ABUTMENT 1 POST TENSIONING DUCT PLACEMENT

40 IDX Drive Building 100, Suite 200 South Burlington, VT 05403 802.497.6100	Job Number: <u>BRF 025-1(42)</u> Reviewed By: <u>E.F. LAWES</u> Date: <u>MARCH 9, 2017</u>

COLD RIVER BRIDGES, LLC	
10 LANBRO LANE WALPOLE, NH	
TEL 603-756-9300	FAX 603-756-9303
POST TENSION DETAILS	
ABUTMENT 1&2 PLAN	SHEET NUMBER
	7
DATE: 11/18/16

ABUTMENT/WINGWALL TYP SECT.
NTS

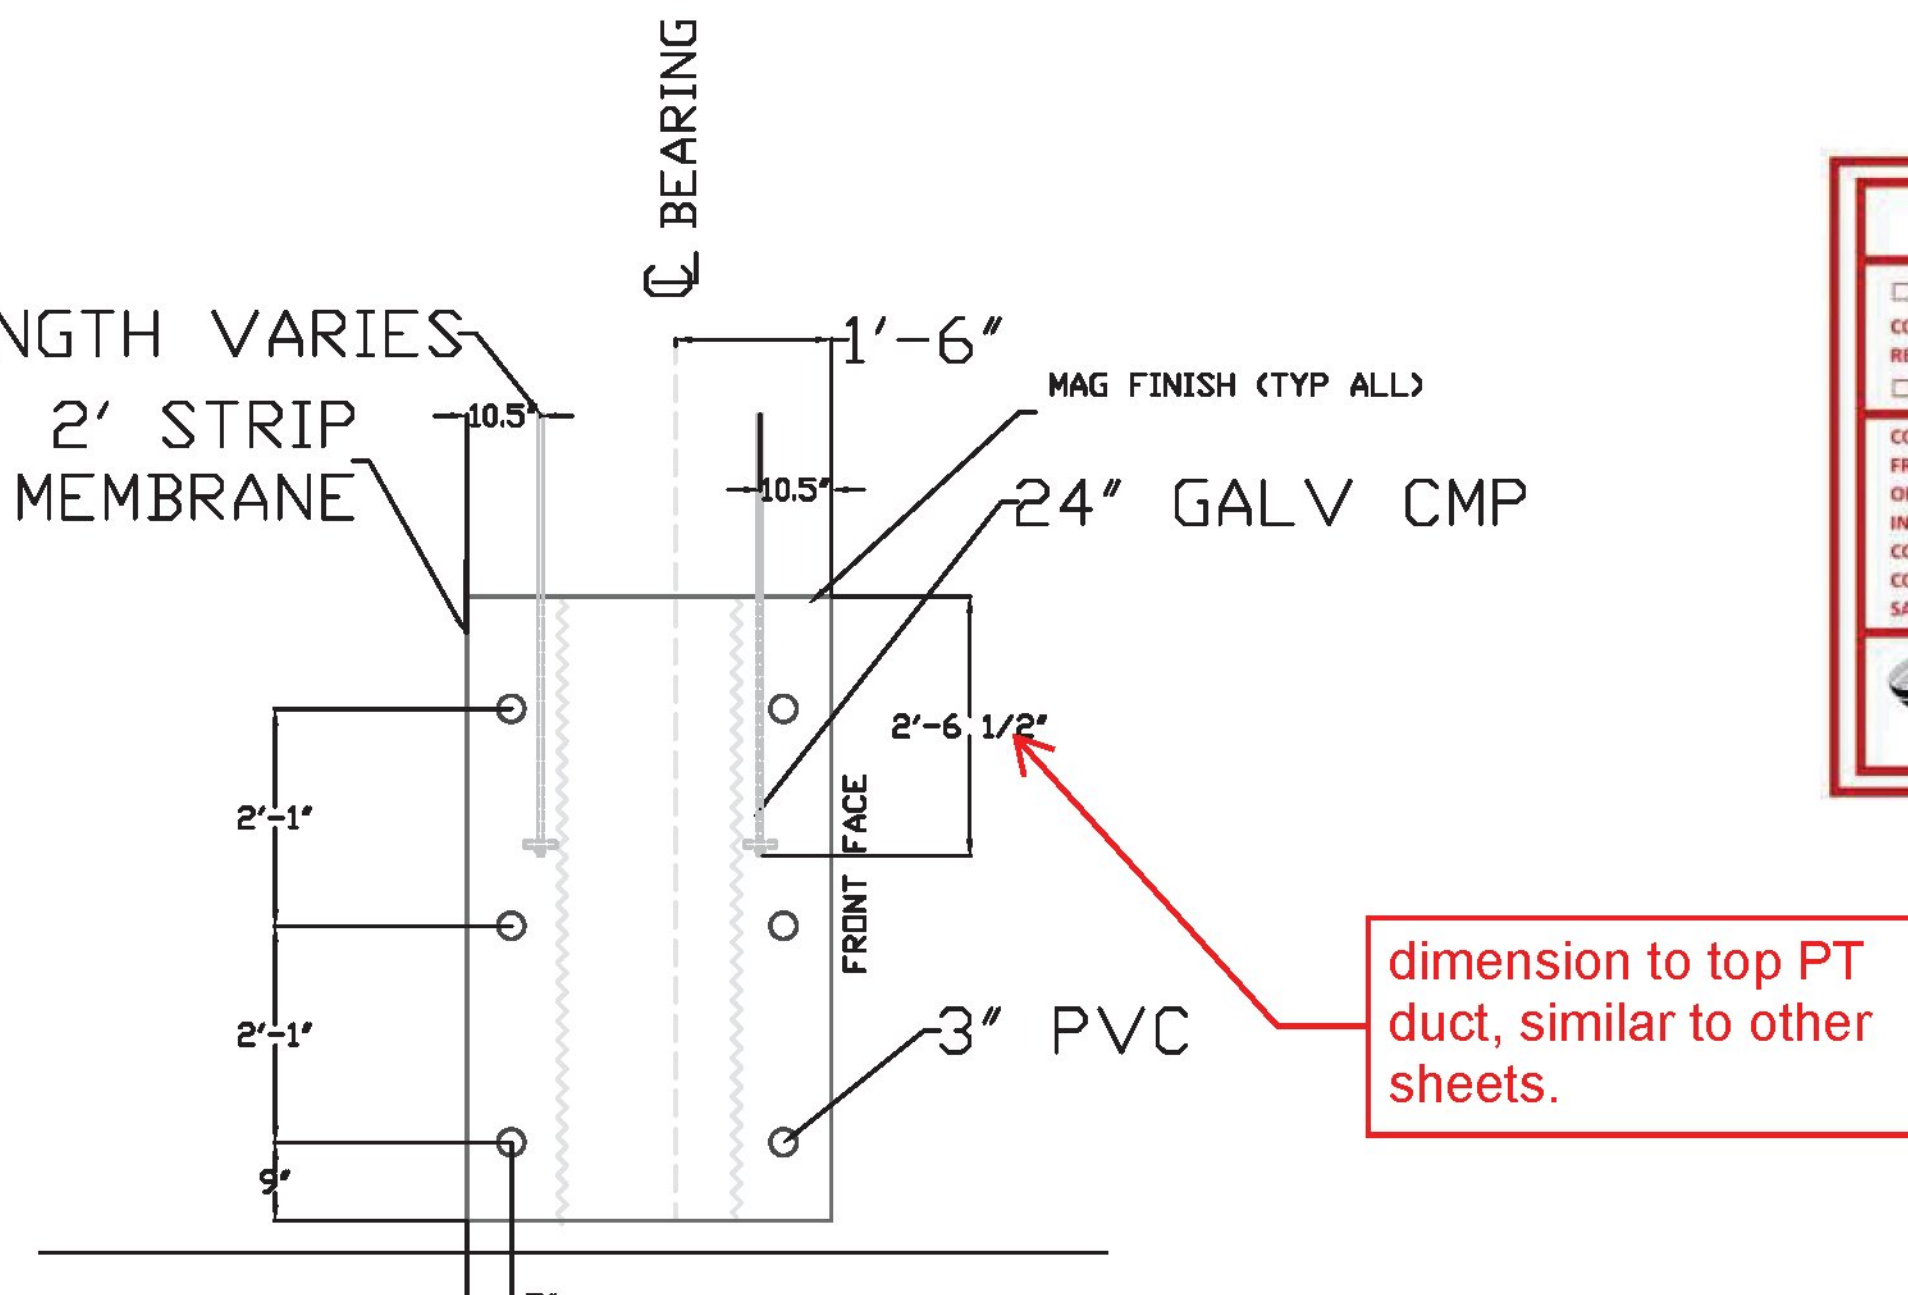
dimension to top PT
duct, similar to other
sheets.
